REVISED RESPONSE TO REQUEST FOR ADDITIONAL INFORMATION

APR1400 Design Certification

Docket No. 52-046

RAI No.: 129-8085
SRP Section: 03.08.01 –Concrete Containment
Application Section: 03.08.01
Date of RAI Issue: 08/05/2015

Figure 5-4 Containment Pressure for Loss of RHR (Mode 5)

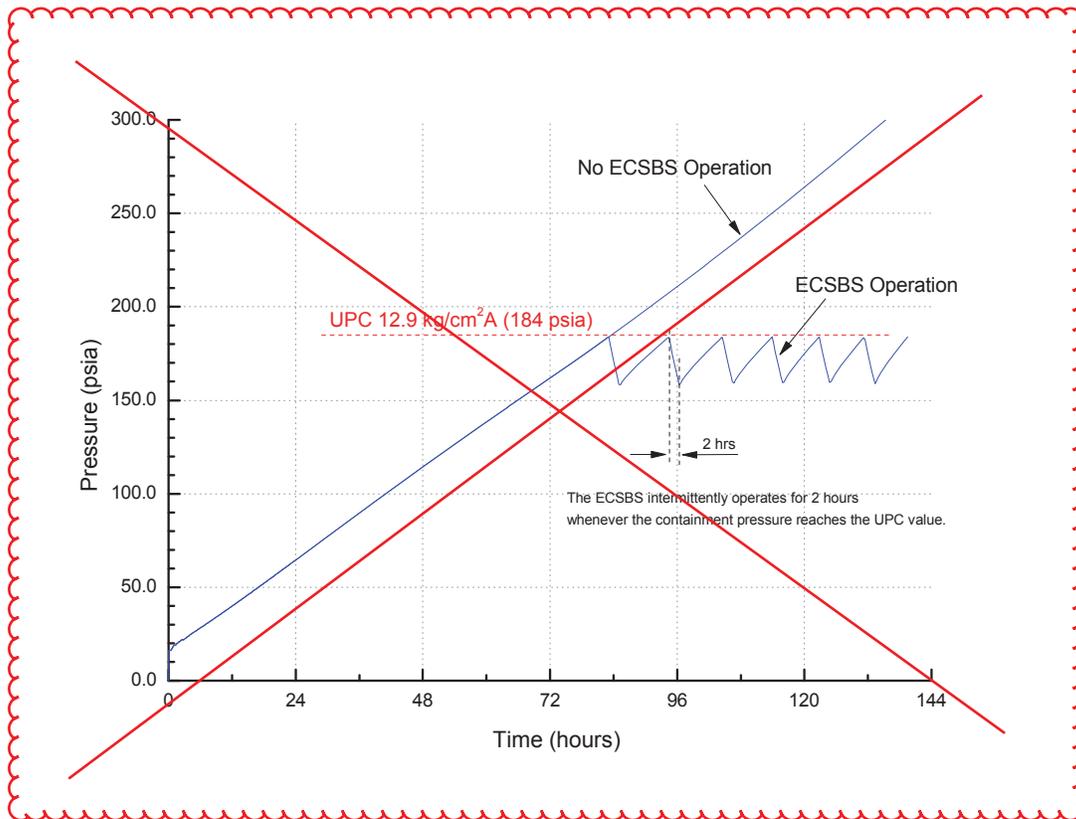
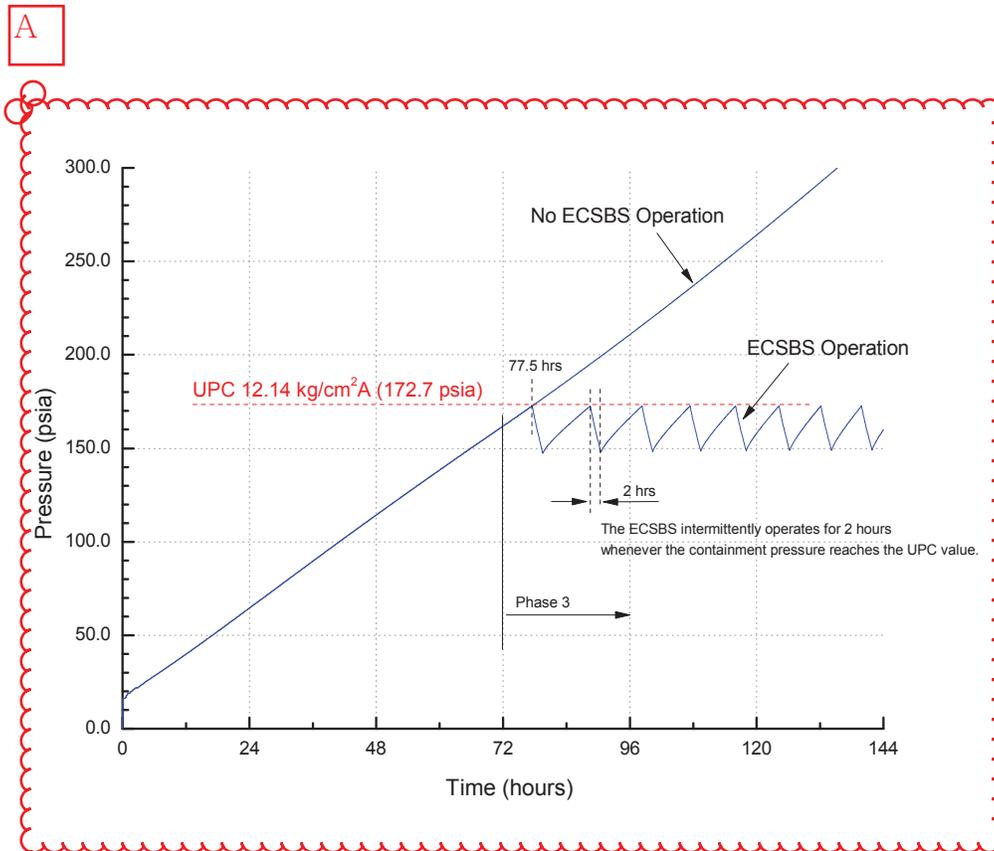
Technical Report "Evaluations and Design Enhancements to Incorporate Lessons Learned from Fukushima Dai-Ichi Nuclear Accident" (APR1400-E-P-NR-14005-P/NP, Rev. 0), Sections 5.1.2.3.3.3, 5.1.2.3.4.6, 5.1.2.5.3, and Figures 5-4 and 5-5 will be revised, as indicated in the attachment associated with this response.

Replaced with next page, A

Due to the mass and energy released from the RCS, containment pressure increases consistently from the beginning of the event, but it can be maintained below UPC by operating the ECSBS intermittently after reaching UPC ~~at around 83 hours~~. The ECSBS is assumed to start spraying water into the containment atmosphere via a FLEX pump when the containment pressure reaches the UPC value of ~~12.9 kg/cm² A (184 psia)~~. After the initial operation, the ECSBS is assumed to be intermittently operated for 2 hours whenever the containment pressure reaches the UPC value. The FLEX pump provides the flow rate of 2,839 L/min (750 gpm) and the differential pressure of at least 2.8 kg/cm² (40 psi) at the ECSBS nozzle. The external water source for ECSBS operation is the RWT.

GOTHIC analyses are performed for evaluation of the containment pressure and temperature responses following loss of RHR in mode 5. Figure 5-4 shows that the containment pressure reaches the UPC value in about ~~3.5 days~~ without ECSBS operation, but with the intermittent operation of ECSBS, containment pressure can be maintained within the UPC limit. Figure 5-5 shows that the containment temperature is maintained well below 185 °C (365 °F), which is less than the upper limit temperature of 196 °C (385 °F) for ensuring the operability of RCS sensors.

Figure 5-5 Containment Temperature for Loss of RHR (Mode 5)

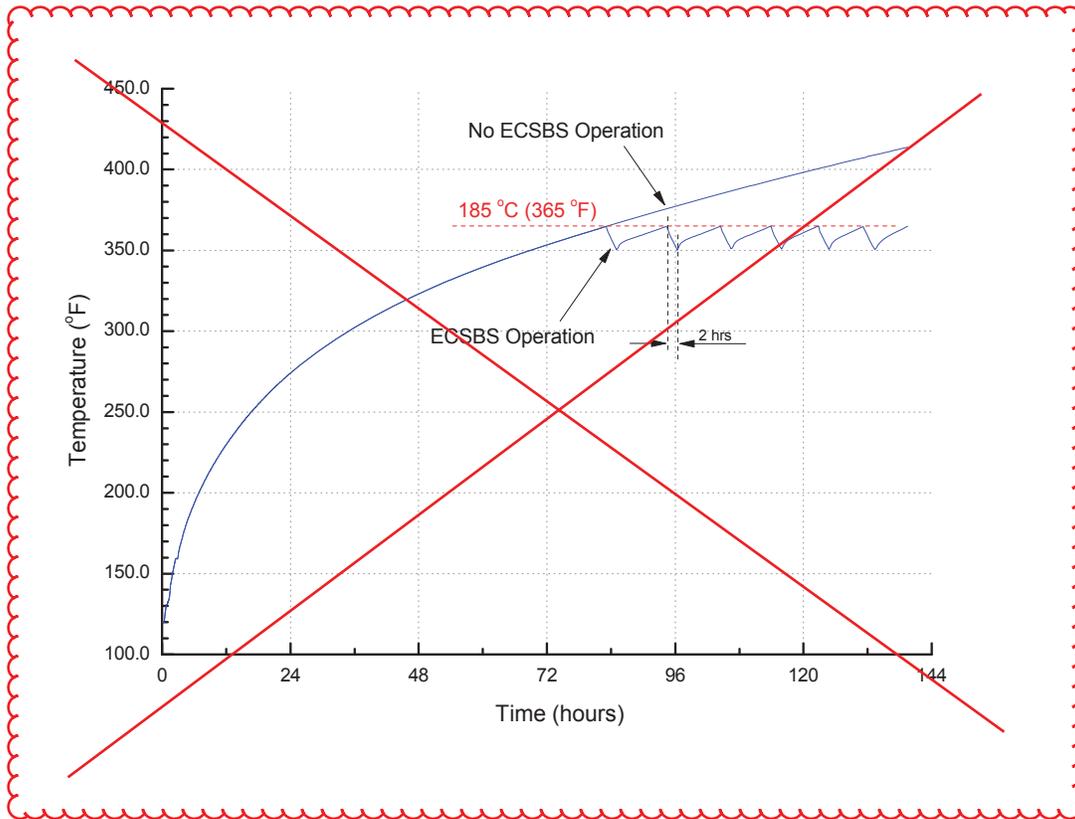
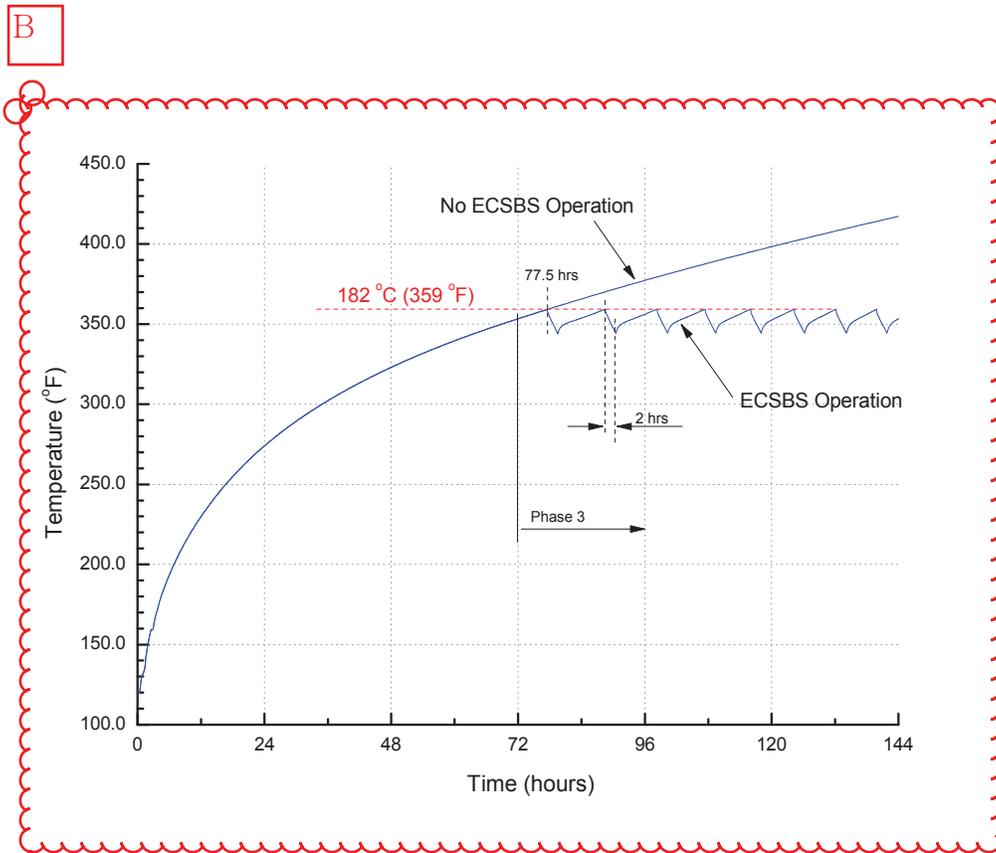
Replaced with next page, B

182 °C (359 °F)
